Response to Submissions

South East Open Cut Project
&
Modification to the
Existing ACP Consent

Ashton Coal Operations Pty Limited

Wells Environmental Services

Figure B1: Hydraulic Properties for Worst Case North-South Oriented Channels Scenario

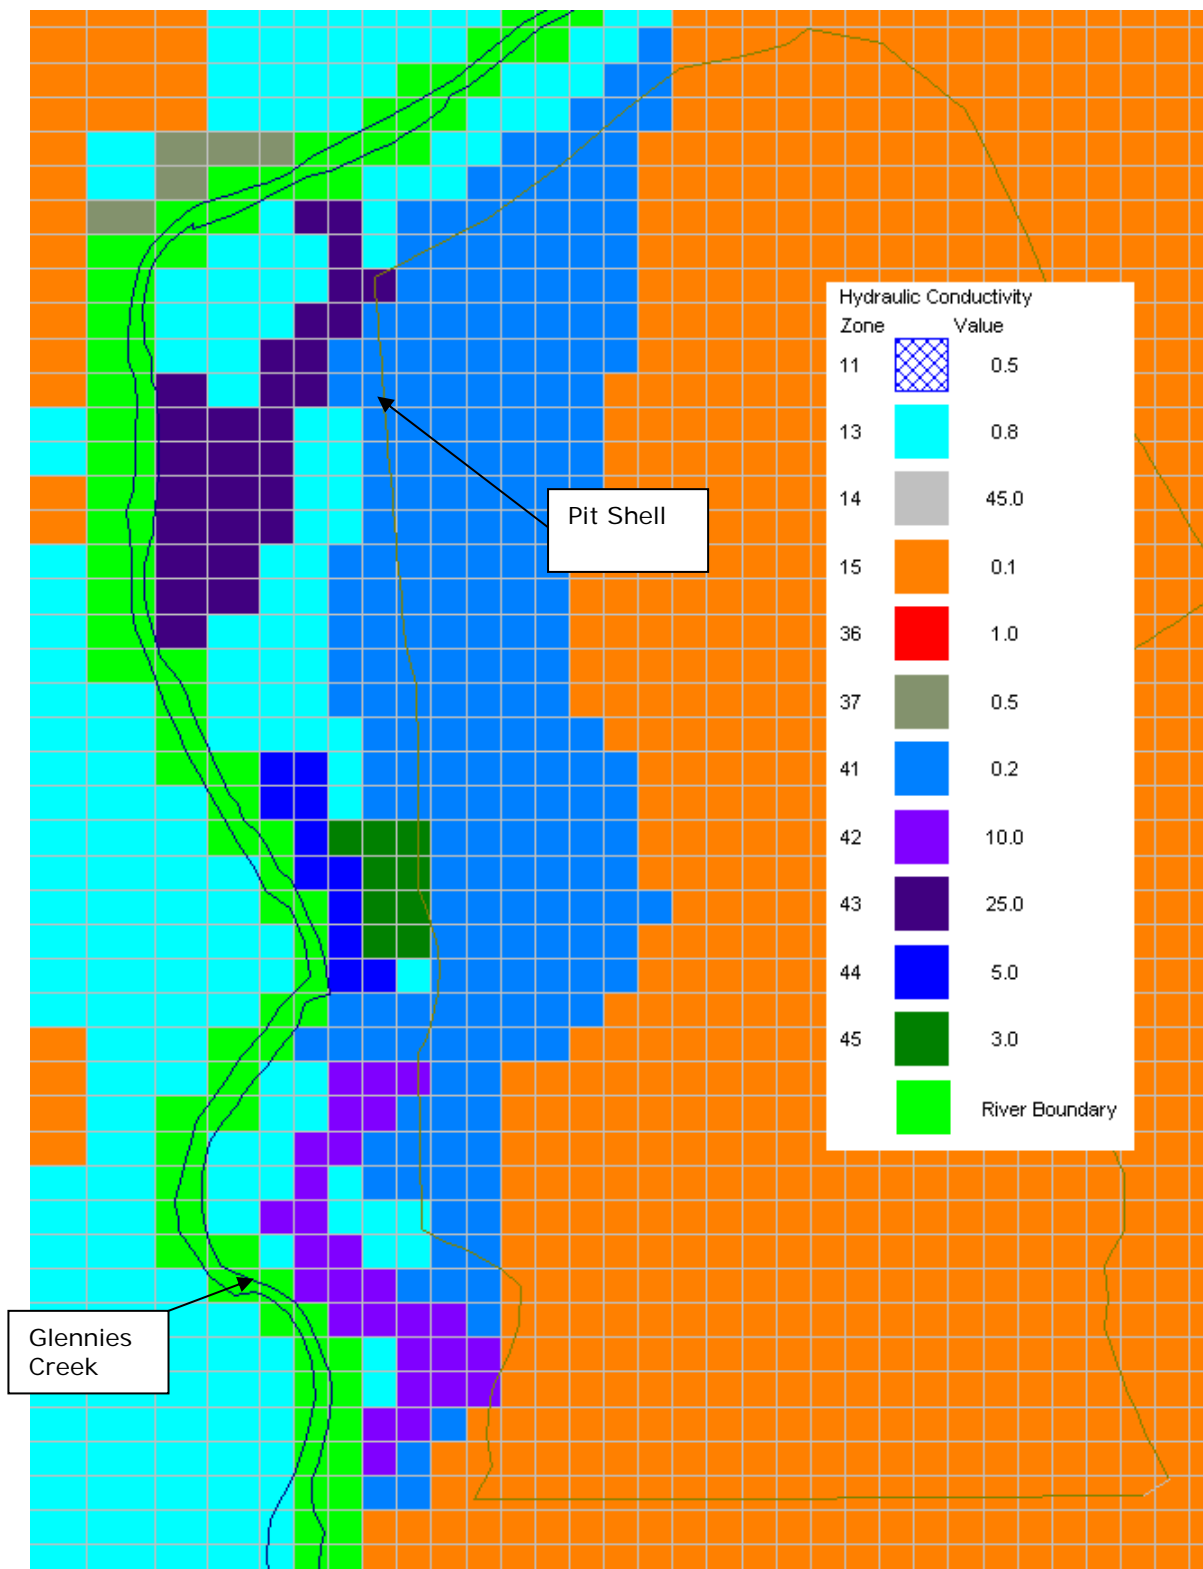
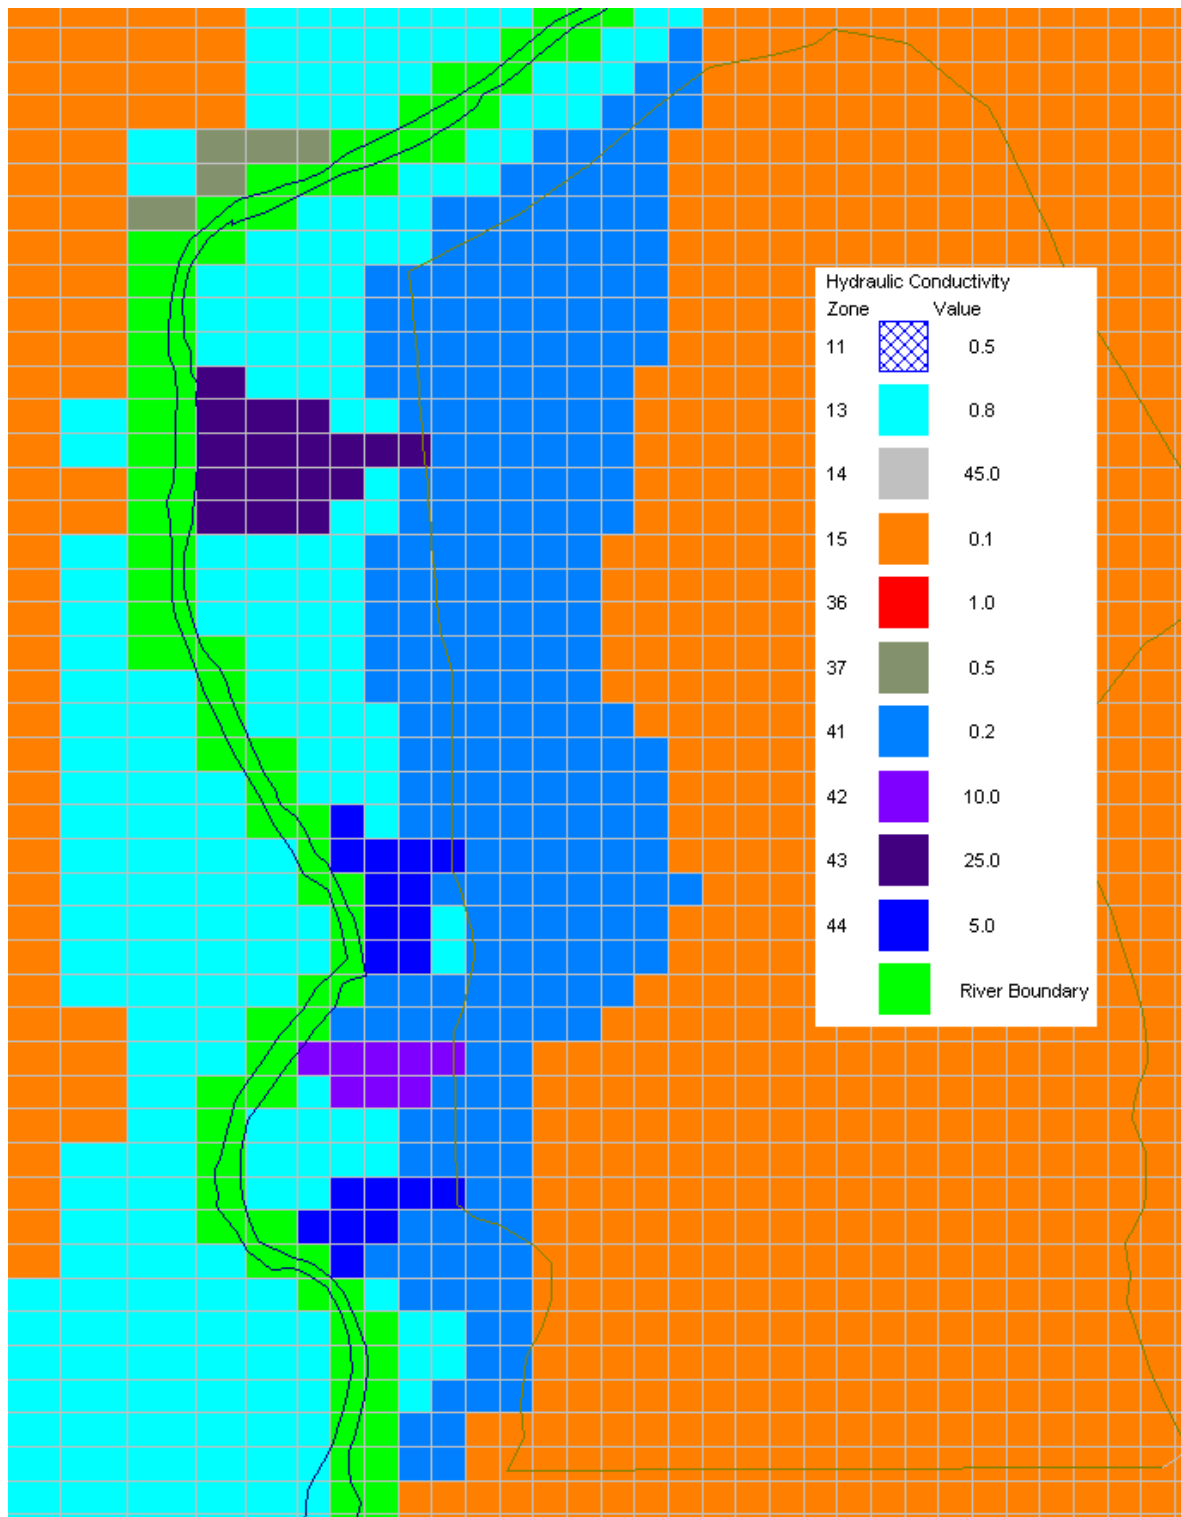
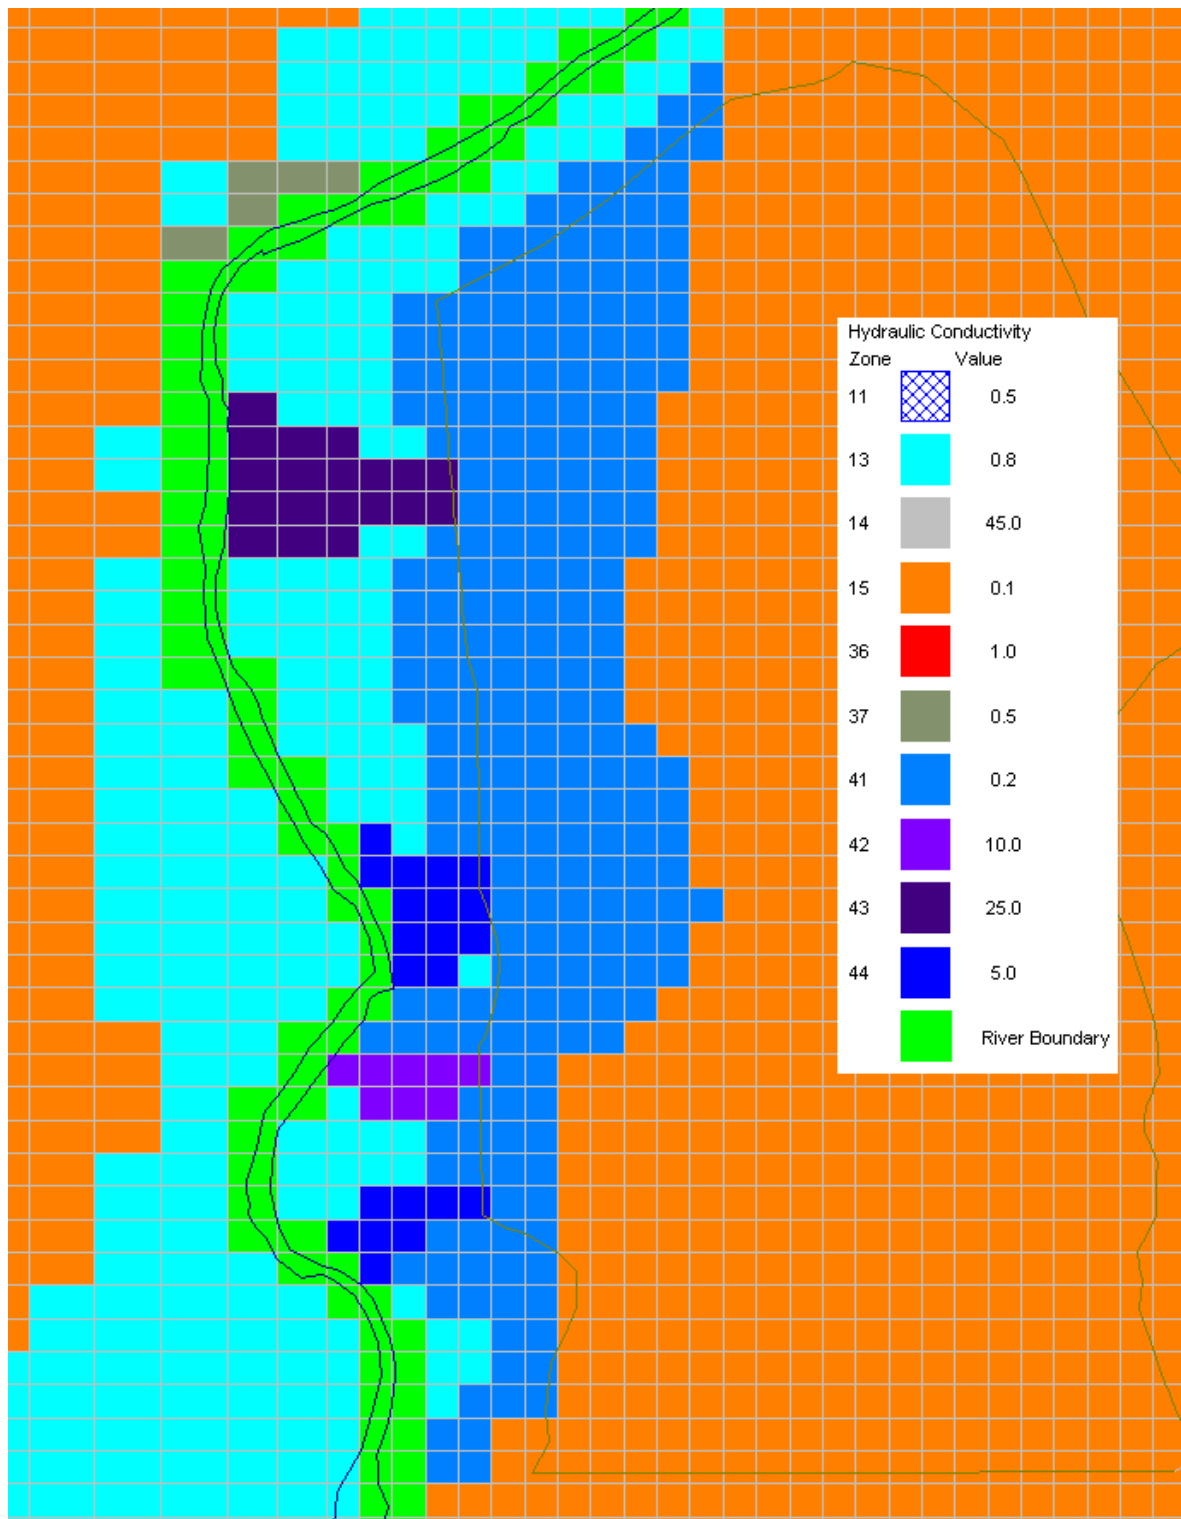
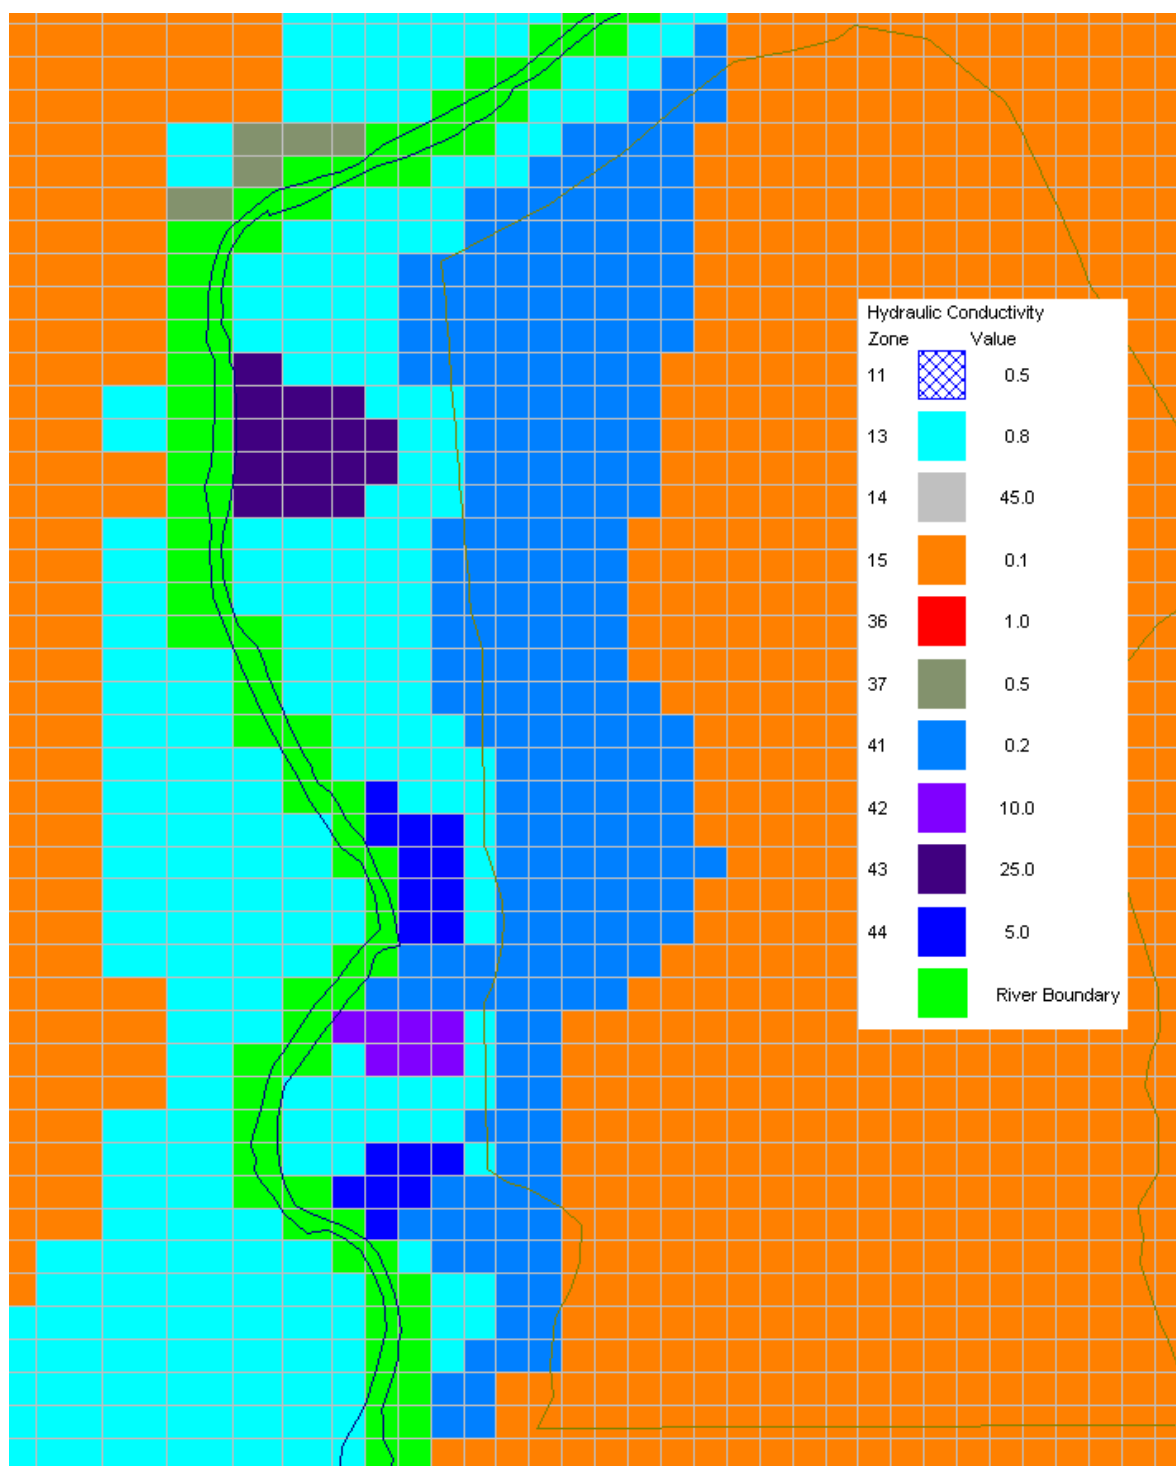
- ▼ *Scenario A: Worst Case North-South Oriented Channels.* For this scenario, high permeability channels have been assumed in all locations where hydraulic testing results did not prove that large, high permeability channels were not present. Embayments have been simulated to try and artificially create links between the pit shell and the creek where there is any feasibility that this might occur. The channel areas have been provided with a hydraulic permeability that is representative of the test results that were found in each given area. The permeabilities used are shown in **Figure B1**. This scenario is as conservative as it can be with north-south trending channels and given the hydraulic test results that were obtained. It is almost certainly excessive, as it assumes high permeability channels that are 50-150m wide that are oriented in the 'worst' realistic way to provide connectivity between the creek and the pit shell.

- ▼ *Scenario 1: Realistic Worst Case.* The hydraulic properties used in this scenario are shown in **Figure B2**. In this scenario, the key high permeability zones have been extended through to the pit shell in all of the areas where the baseline studies indicated that there could be an east-west cross connection caused by historic east-west drainage and associated embayments. Because the model uses cells that are 50m by 50m, this effectively assumes that clean gravels with an average conductivity of between 5 and 20m/d intersect the pit shell in channels 50m wide at four separate locations. This is not supported by the EC results and contours, but it is acknowledged that it is feasible given the granularity of the hydraulic testing programme that was carried out at the site.

- ▼ *Scenario 2: Maximum Potential 'Braiding' Connectivity.* The hydraulic properties used in this scenario are shown in **Figure B3**. For this scenario, hydraulic properties in the two zones where saturated gravels are present at the pit shell have been modified so that high permeability extends through to the pit shell across the whole of the potential area where significant saturated gravels exist and hydraulic testing has not actively proved there is low permeability. This means that the two high permeability zones in the northern part of the model intersect the pit shell over lengths of 100m and 150m respectively. Pit inflows are more sensitive to the larger, more southerly of these zones, which has been assigned a permeability that is higher than any of the actual values that were recorded during testing near the pit shell.

- ▼ *Scenario 3: Generalised Background Connectivity.* The hydraulic properties used in this scenario are shown in **Figure B4**. For this scenario, the potential risk that small, regular, partly clean gravel braids could intercept the pit shell over a wide area has been evaluated. This has been done by effectively increasing the extent of the 0.8m/d permeability zone so that it extends across any areas near the pit shell where there might be embayments or cross connections caused by the historic east-west drainage patterns. It should be noted that this does not reflect the results of the hydraulic testing, and effectively assumes that the hydraulic testing that was carried out tended to intersect lower permeability areas for some unknown reason.
